## Technical Note: Response to Council's email dated 26<sup>th</sup> January 2018 regarding Service Access

**Delfont Mackintosh Theatres** Sondheim (Ambassadors) Theatre, West Street, London Technical Note: Response to Camden Council's email dated 26th January 2018 regarding Servicing Access

Figure 1.1: Vehicle Used

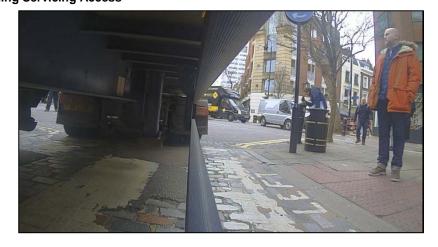
- "Looking at the attached PDF "Lorry Vehicle Tracking-Model2", this manoeuvre does not work and would cause damage to the grade 2 list statue in the middle of the dials. There are no engineering solution that we would be will to undertake to solve this issue. The applicant needs to find a solution to this, otherwise we will need to restrict the size of vehicle that can service the theatre."

- 1.2 To address the concern of the council, a trial experiment where an articulated vehicle of 16.5m length was undertaken on the 8<sup>th</sup> February 2018. Note: This is the vehicle type used by the Council for its response of the 26<sup>th</sup> January 2018.

- 1.3 This Technical Note reports on the findings. The vehicle used for the experiment is shown in **Figure 1.1**.
